# ATTACHMENT 1

## CONCEPT INTERSECTION DESIGNS

Project Title  
 Ruakaka Service Centre

Figure 3: Proposed raised table intersection at service centre threshold

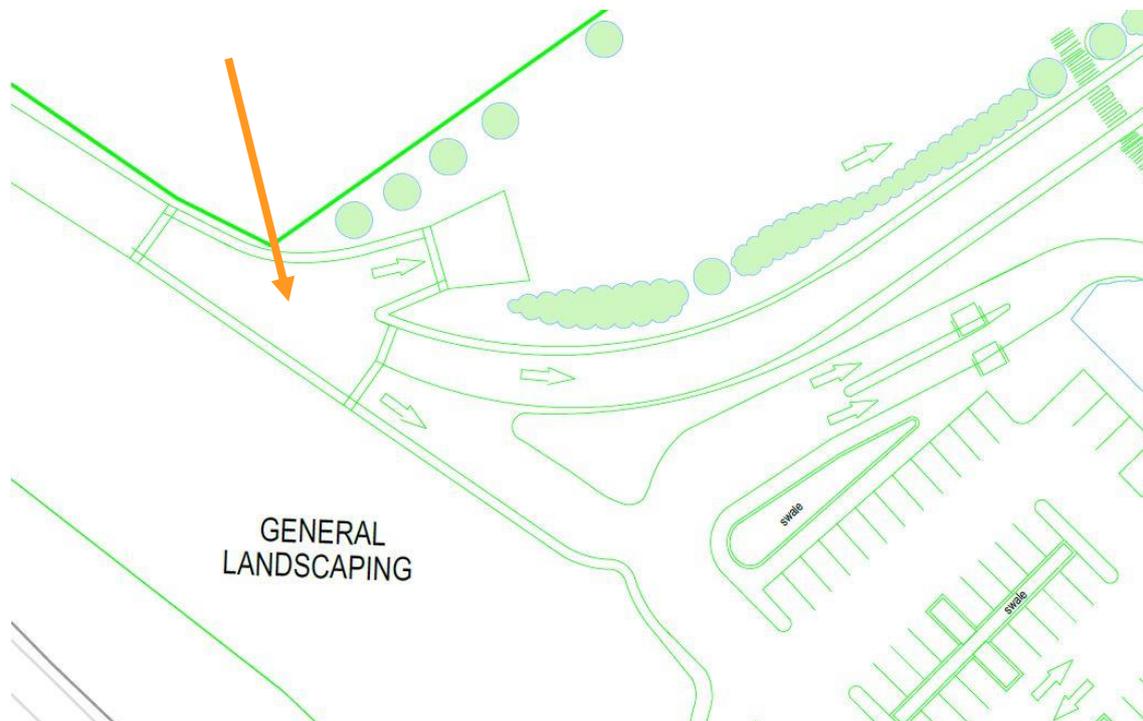
<sup>2</sup> The road safety audit team assumes that the arrowed section in Figure 3 is indeed a raised table. If it is not, then it should be.

Designer response	The arrowed section in Figure 3 is indeed a proposed raised table and will not be omitted.
Safety Engineer comment	Insert comment
Client decision	Insert comment
Action taken	Insert comment
